Indiana University - South Bend  
20230612 SB850 Northside Hall - Mechanical System Replacement, Partial AHU East  
12/3/2024

**ADDENDUM NO. 2**

**1 DEMOLITION FLOOR PLAN - BASEMENT LEVEL - UNIT B**  
 SCALE: 1/8" = 1'-0"  
 NORTH

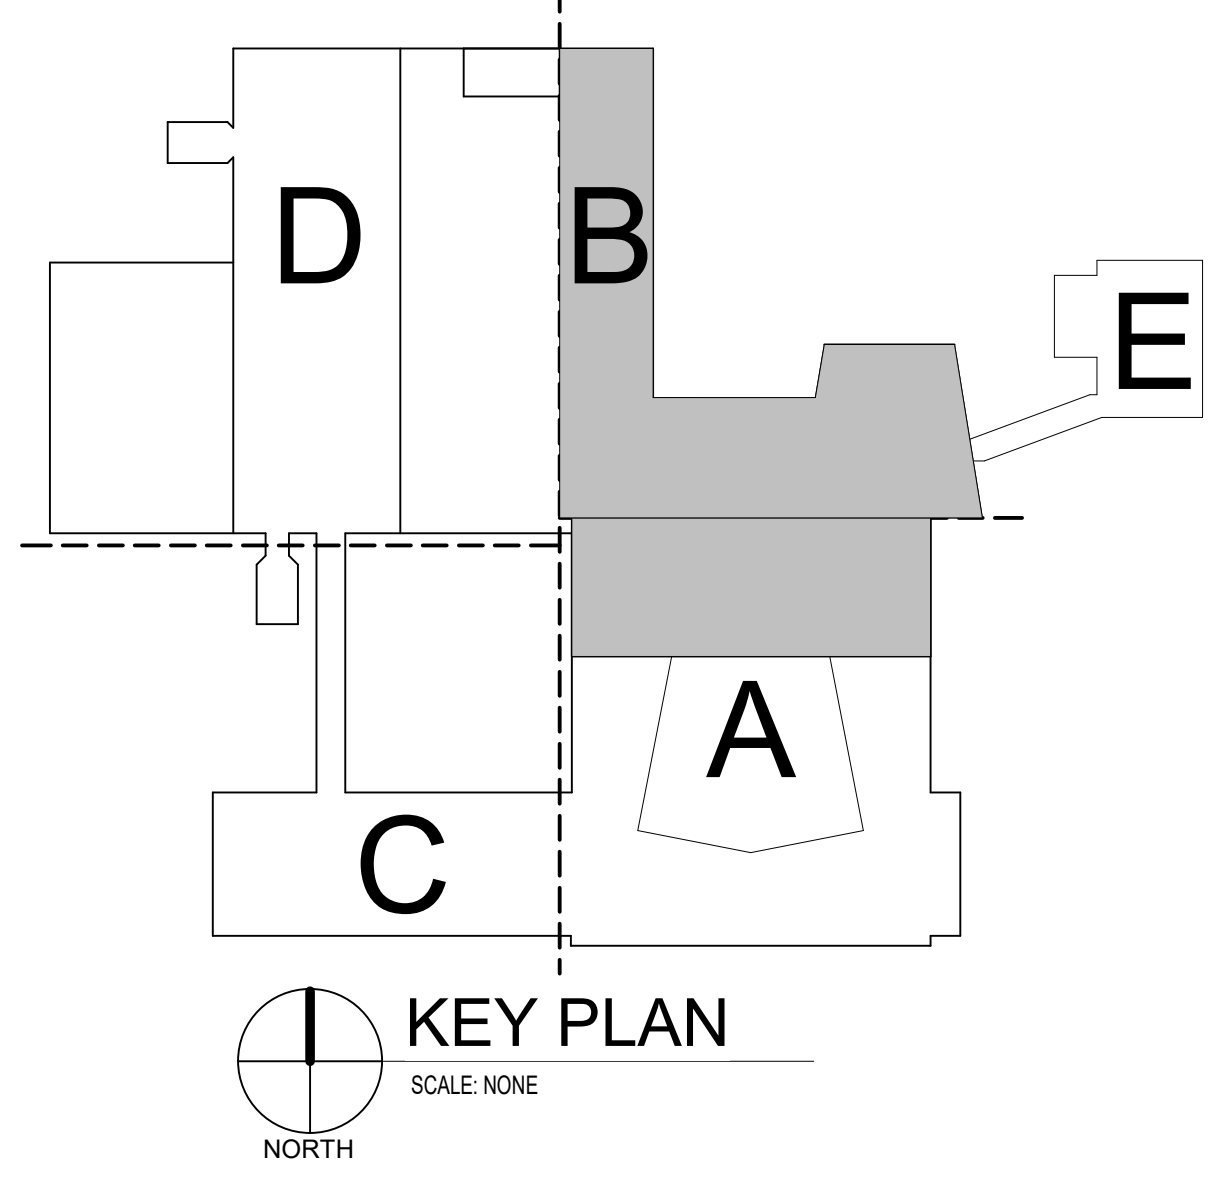
- Item: 2.01**  
Location: Drawings, Sheet AD1.0 Demolition Floor Plan – Basement Level, Unit B and Sheet A1.0B, Floor Plan – Basement Level, Unit B  
Description: East wall of new mechanical enclosure in Mail Room/Print 0028: Remove existing wood door, related door hardware and stained wood trim on both sides of the door opening. Infill the wall opening with new framing and gypsum board to create flush condition on both sides of wall.
- Item: 2.02**  
Location: Drawings, Sheet AD1.0 Demolition Floor Plan – Basement Level, Unit B and Sheet A1.0B, Floor Plan – Basement Level – Unit B  
Description: a. South wall of new mechanical enclosure in Mail Room/Print 0028: Existing framed wall to remain. Remove existing wood trim at head and jambs of large wall opening and infill opening with new framing and gypsum board to create flush condition on both sides of wall.

D 103	EXISTING FLOORING TO REMAIN. PROTECT DURING CONSTRUCTION ACTIVITIES.
D 104	REMOVE EXISTING CARPET AND FLOOR BASE. COORDINATE REMOVAL OF ASBESTOS SHG TILE WITH IUSB (SEPARATE CONTRACT).
D 703	REMOVE EXISTING DOOR, RELATED DOOR HARDWARE, AND STAINED WOOD TRIM ON BOTH SIDES OF THE DOOR OPENING. IN FILL THE WALL OPENING WITH NEW FRAMING AND GYPSUM BOARD TO CREATE FLUSH CONDITION ON BOTH SIDES OF WALL.
D 705	REMOVE EXISTING WOOD TRIM AT HEAD AND JAMBS OF EXISTING WALL OPENING AND IN FILL OPENING WITH NEW FRAMING AND GYPSUM BOARD TO CREATE FLUSH CONDITION ON BOTH SIDES OF WALL.
MD4	MECHANICAL EQUIPMENT TO BE REMOVED. SEE MECHANICAL SHEETS.

**FLOOR PLAN - BASEMENT LEVEL - UNIT B**  
 SCALE: 1/8" = 1'-0"

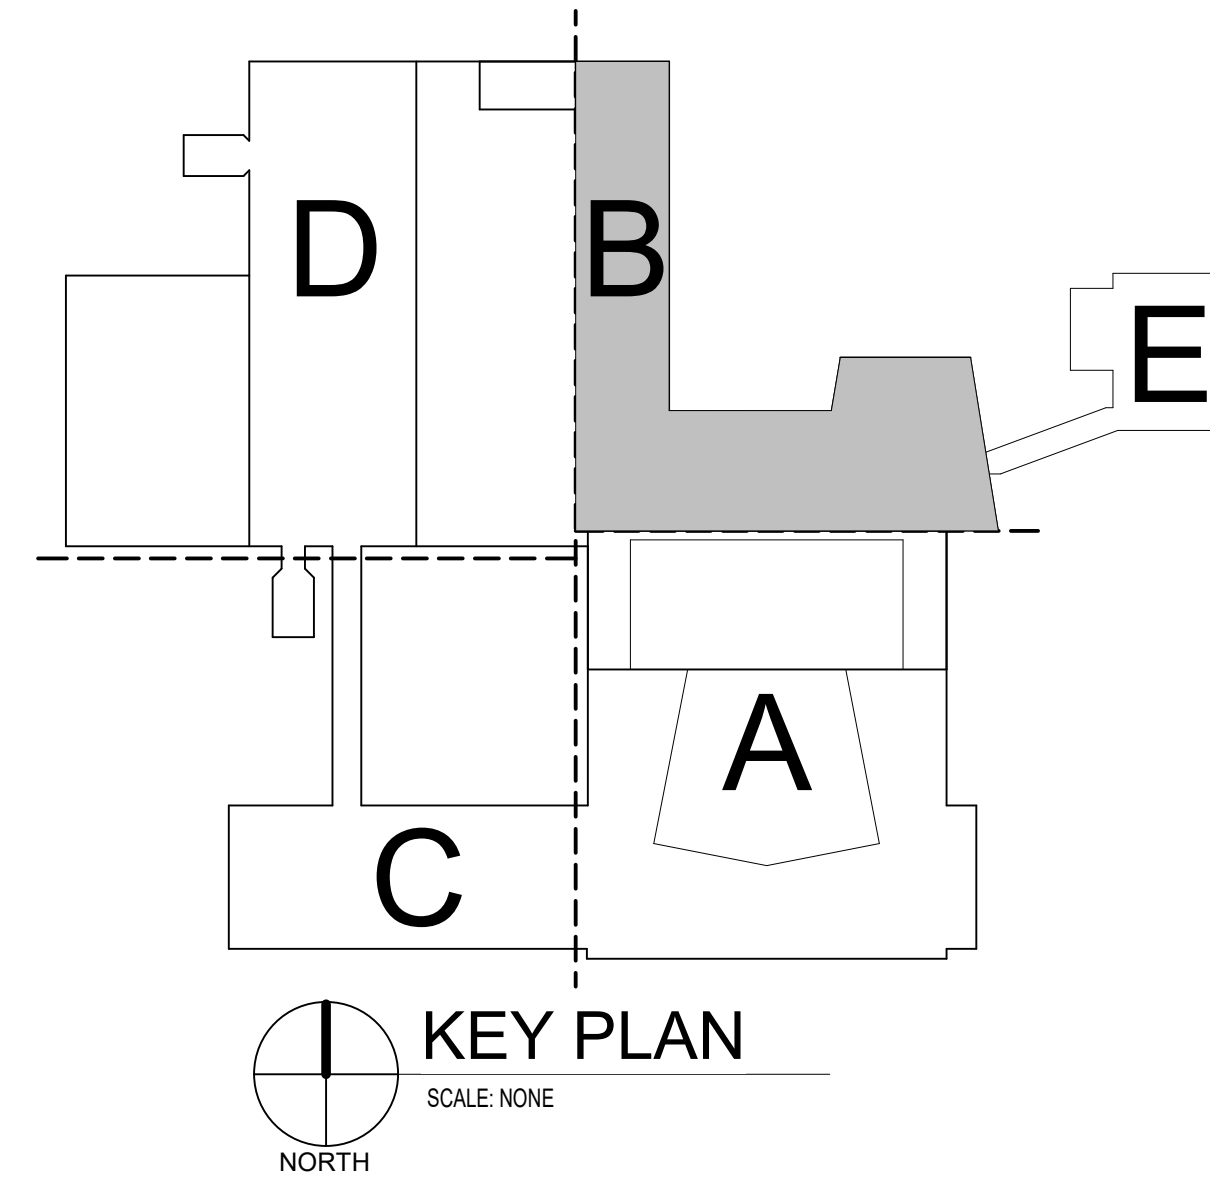
b. Extend height of existing wall construction on south and east sides of new mechanical enclosure to be 6” above new ceiling system elevation.
- Item: 2.03**  
Location: Project Manual  
Description: Delete Specification Section 08 11 13 Hollow Metal Doors and Frames from the project manual.
